UNITED STATES PATENT AND TRADEMARK OFFICE

APPLICATION NO.	FILING DATE	FIRST NAMED INVENTOR	ATTORNEY DOCKET NO.	CONFIRMATION NO.
10/088,050	08/12/2002	Dany Ray	Q68978	6570

Office Action Summary	Application No. 10/088,050	Applicant(s) RAY ET AL.	
	Examiner Frederick C. Nicolas	Art Unit 3754

FIG. 2

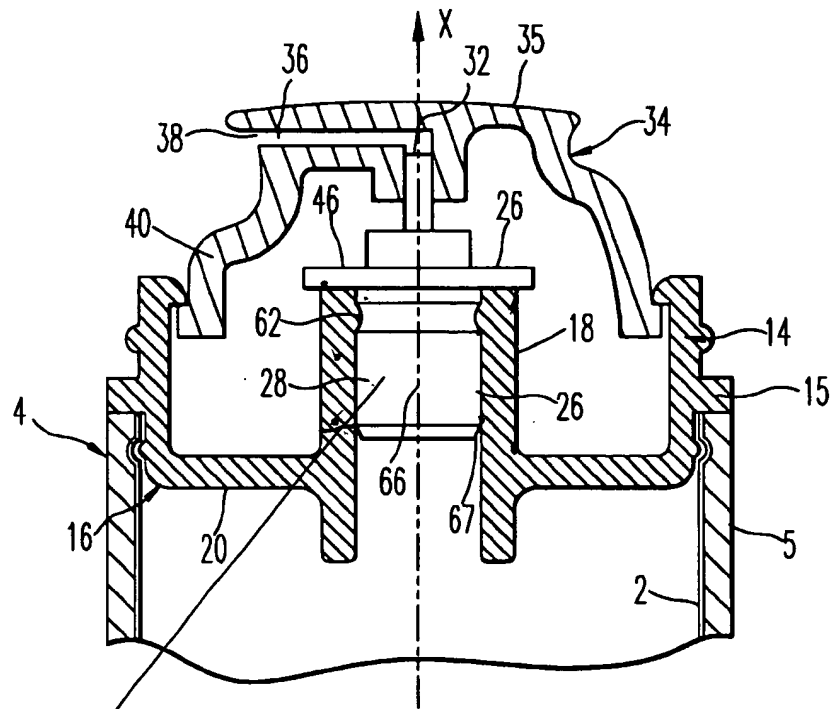
Gueret discloses a fluid dispenser device designed to be mounted on the neck of a receptacle (4) as seen in Figure 2, which comprises a dispensing member (26), fixing means for fixing the dispensing member to the neck of the receptacle (col. 4, ll. 27-67), the dispensing member comprises a body (28) whose top end is provided with a collar

(46) that projects outwards, the fluid dispenser device being characterized in that the fixing means comprise a substantially cylindrical ring (18) engaged on the body under the collar as seen in Figure 2, the ring being in peripheral leaktight contact with the body by being radially clamped thereon (col. 6, ll. 47-48), the ring defines a top end in abutment under the collar as seen in Figure 2, the body also forms at least one outwardly-projecting bulge situated below the collar (46) see attached Figure 2 for location of the at least one outwardly-projecting bulge, the ring being disposed between the collar and the at least one bulge so that the ring is locked therebetween as seen in Figure 2, the free top end of the ring is provided with an inside bevel to make it easier for the ring to pass over the bulge (col. 5, ll. 34-46 and as seen in Figure 2), a radial flange (20) serving into abutment against the neck of the receptacle, a socket (16) being extended downward and configured to be crimped (col. 4, ll. 11-26).
